Aviation Peer Review:

Sunfield Masterplanned Community

16 April 2024

Avlaw Aviation Consulting Pty Ltd (Avlaw) has been engaged by Sunfield Developments Limited (Sunfield) to complete a peer review of an aviation safeguarding and airport compatibility assessment prepared by Lambert & Rehbein (L&R), referred to herein as "the report". The report set about identifying any aviation restrictions which have the potential to impact proposed development across a large parcel of land which collectively forms the Sunfield Masterplanned Community, referred to herein as "the site".

Figure 2: Various illustrations of the windshear and turbulence trigger areas (taken from [NASF](#) Guideline B)

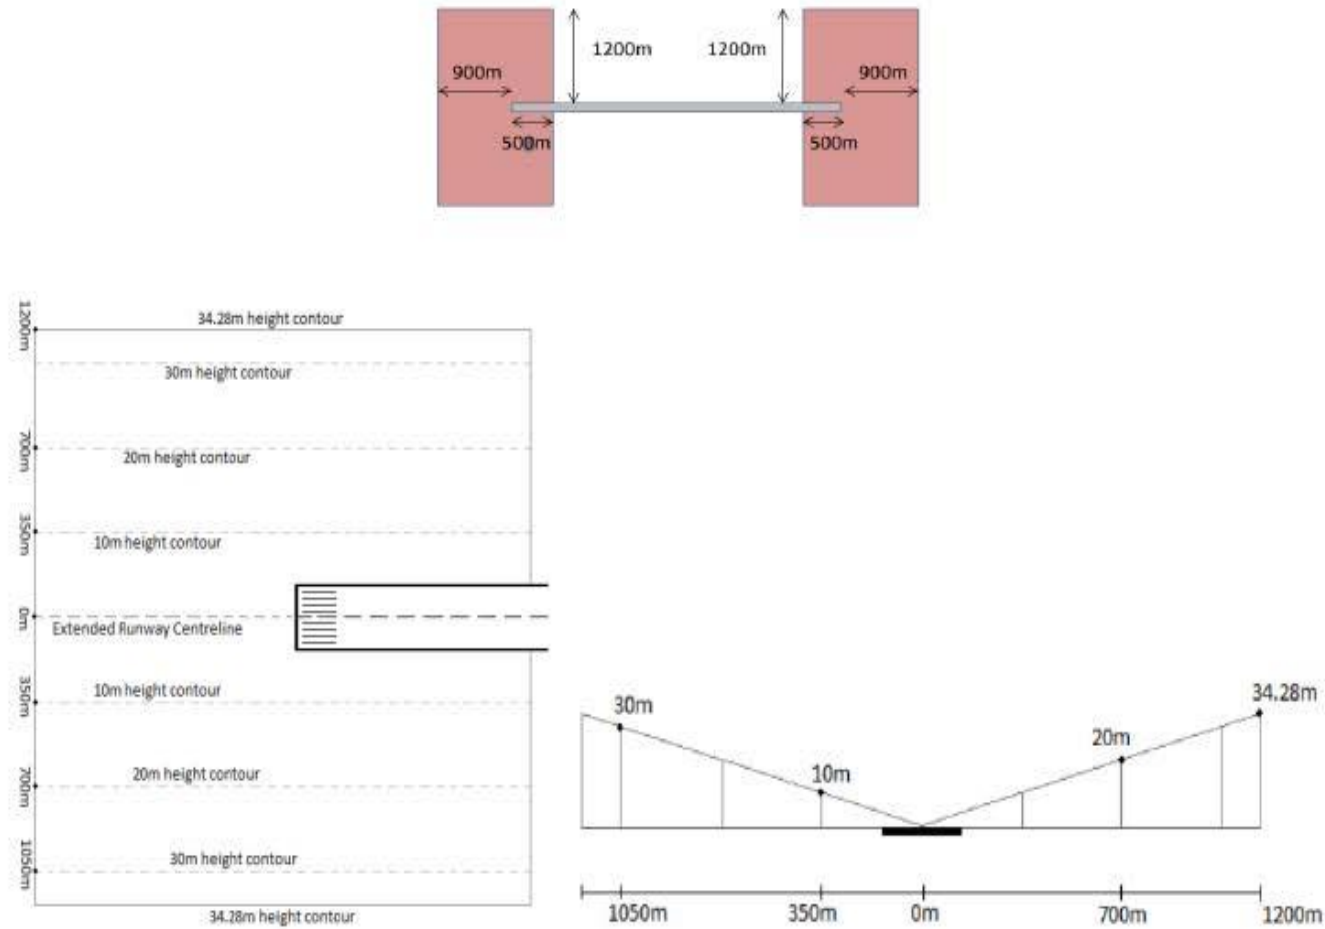
Ardmore Airport			
Criteria	Figure(s)	Effect on the site	Effect on the Business Park
Windshear and Turbulence	2, 3	The majority of the site and Business Park is covered by the windshear and turbulence trigger area which requires a detailed wind study to be completed if a permanent structure is proposed to penetrate the 1:35 surface which extends laterally from the runway centreline within a region 900m from each runway threshold. With respect to the site and the Business Park, this results in the trigger surface rising laterally from the runway from 32.6m AMSL to 66.88m AMSL before the assessment area terminates. Given the extent to which this would limit the height of built structures, Sunfield may consider it of sufficient benefit to seek preliminary advice from a specialist qualified to conduct Computational Fluid Dynamics (CFD) or equivalent modelling to determine if pursuing approvals above the 1:35 surface are likely to yield positive results.

Figure 7: Critical (i.e. lowest) OLS surface for the RWY03/21 over the site and Business Park – approach surface showing no 52m AMSL (20m AGL) buildings intruding

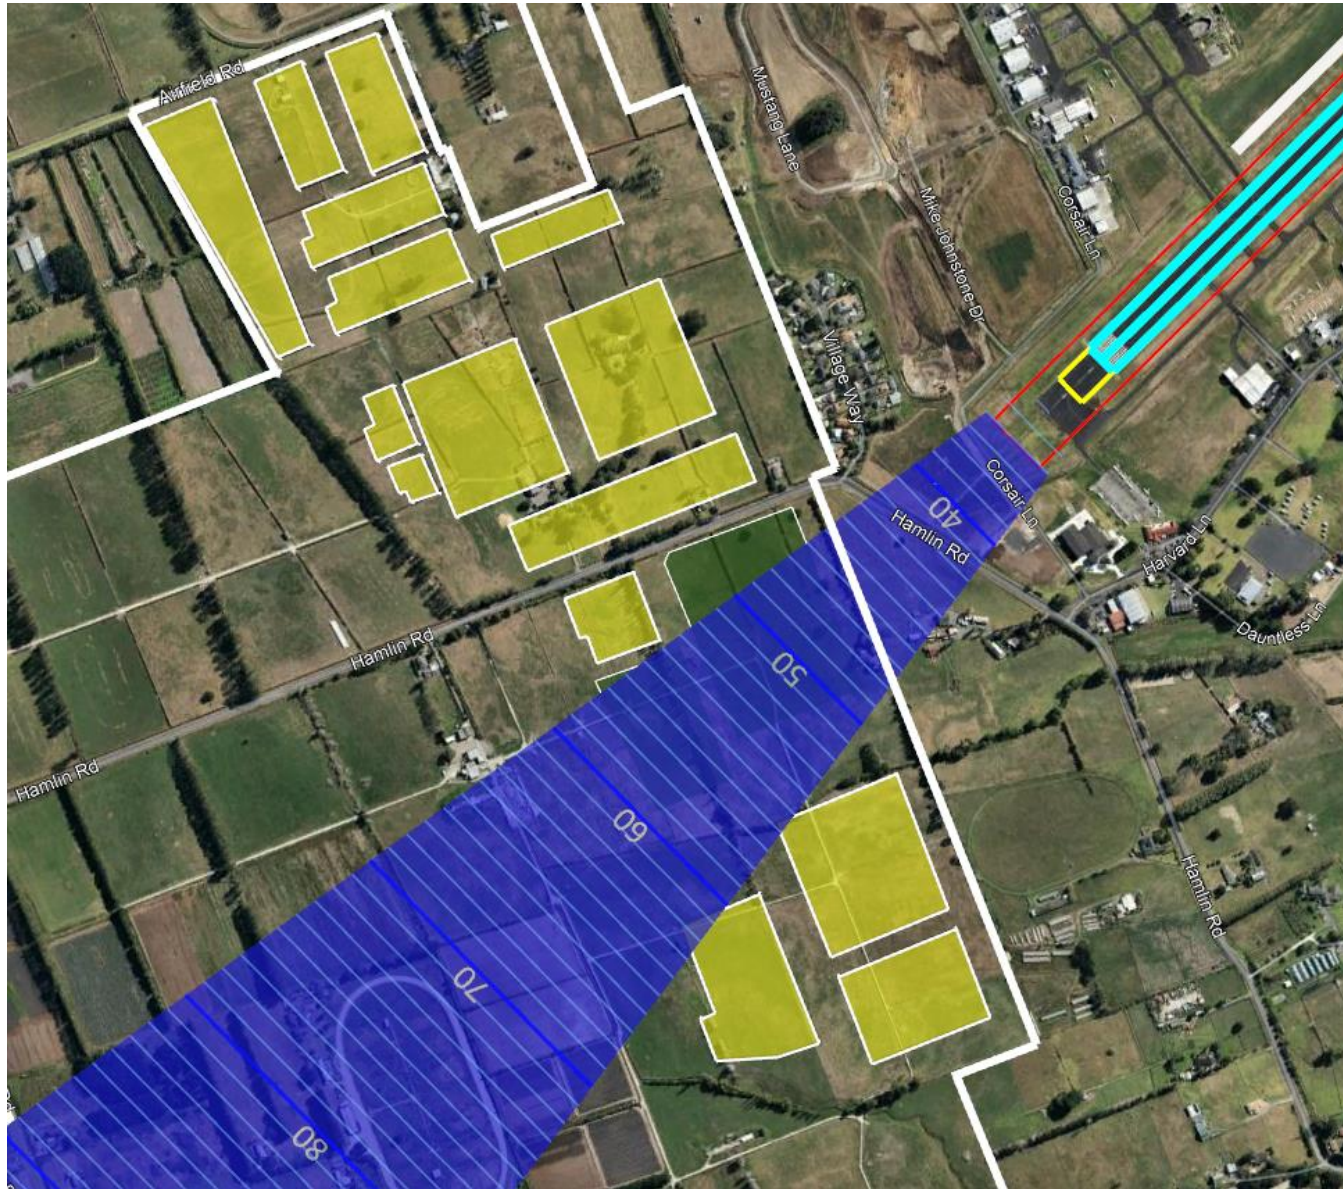
Prescribed Airspace: Obstacle Limitation Surfaces (OLS)	5, 6, 7	Most of the site is unaffected by the most critical (i.e. lowest) OLS surface for the main runway at Ardmore Airport i.e. approach surface. The land which sits beneath this surface on the extended centreline to the main runway cannot be penetrated permanently and temporary penetration will only be approved when the main runway is not operational. There is a small area at the very northern tip of the site which sits beneath the approach surface for the northern grass runway, however this is N/A as Avlaw has discovered that it is no longer utilised as a runway.	Yards 1 and 2 will be most restricted with respect to the height of built and temporary structures. Sunfield is aware of this already and as such has proposed yards for storage and parking in this area. None of the other building in the Business Park to a height of 52m AMSL will penetrate the most critical OLS surface.

Figure 10: Critical surfaces combination – turbulence trigger (green), SID surfaces (purple) and approach OLS (blue)

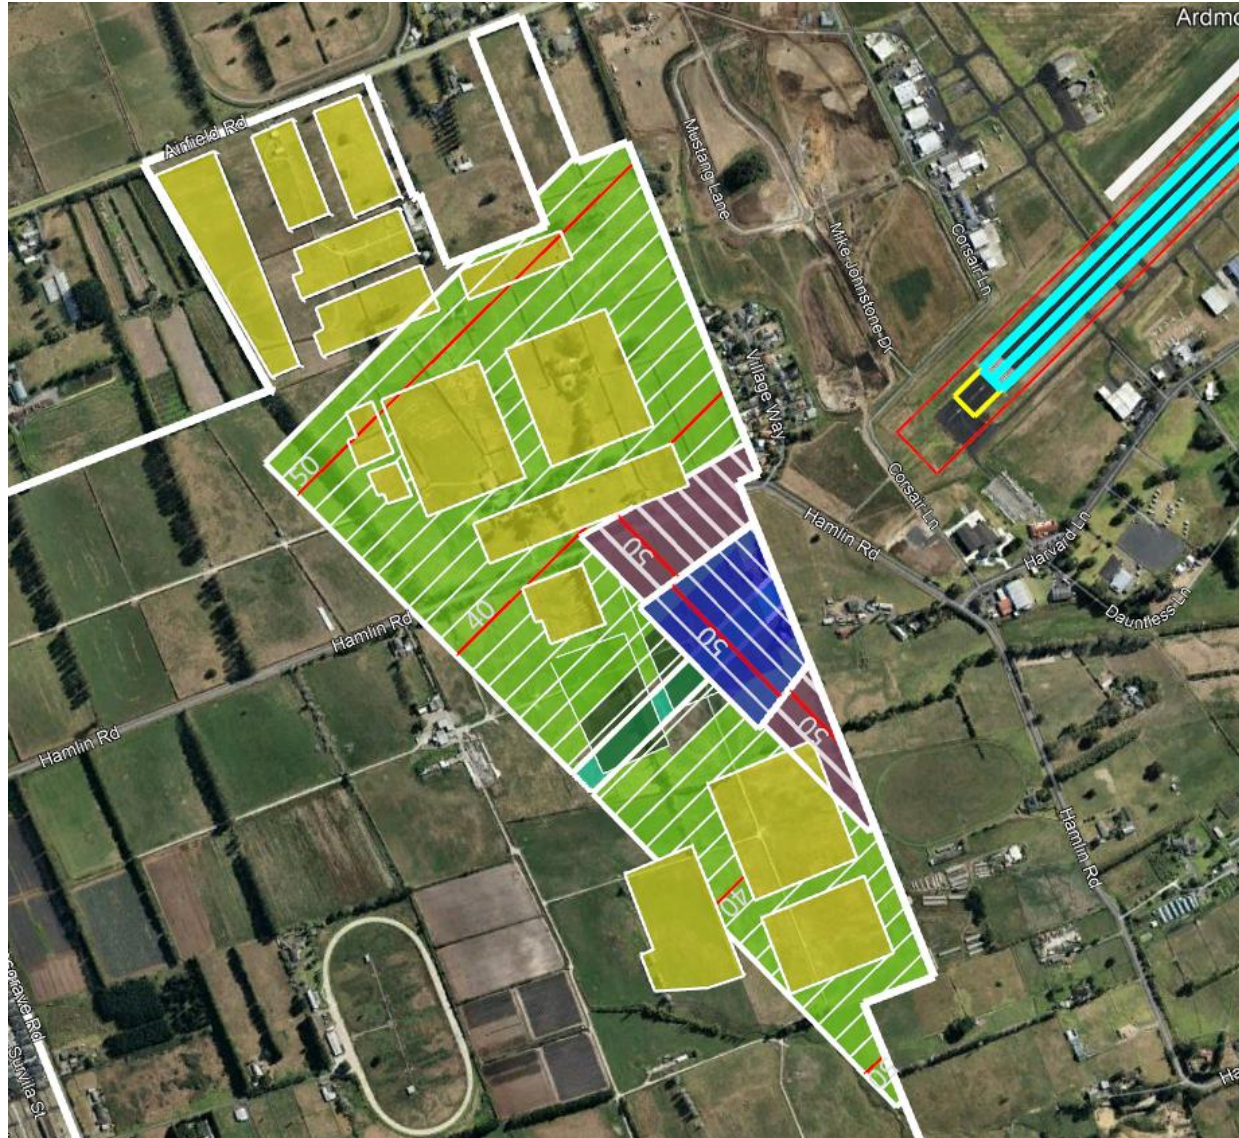
The figure on the following page provides a snapshot of the aviation restrictions which most limits the height of development across the Business Park. This essentially amalgamates the most relevant figures inserted in section two and only shows the most restrictive aviation requirements across this piece of land. Specifically, it shows a combination of the following:

- Windshear and turbulence trigger shown at Figure 3 (green);
 - The light blue area represents the extended runway which is inserted as a point of reference for point at which the windshear and turbulence trigger surface commences
- the OLS approach surface shown at Figure 7 (blue); and
- the SID surfaces shown at Figure 8 (purple).

In the interests of being thorough and identifying all the airspace protection surfaces that cover the site and the Business Park, the SID surfaces are included. However, as noted at Figure 1, the purple SID areas can be ignored from a practical perspective when trying to determine the maximum height of development. Although it is prudent to mention, the gradients need not consider obstacles below 60m AGL and as a result, another iteration of Figure 10 which removes these SID surfaces is inserted as Figure 11.
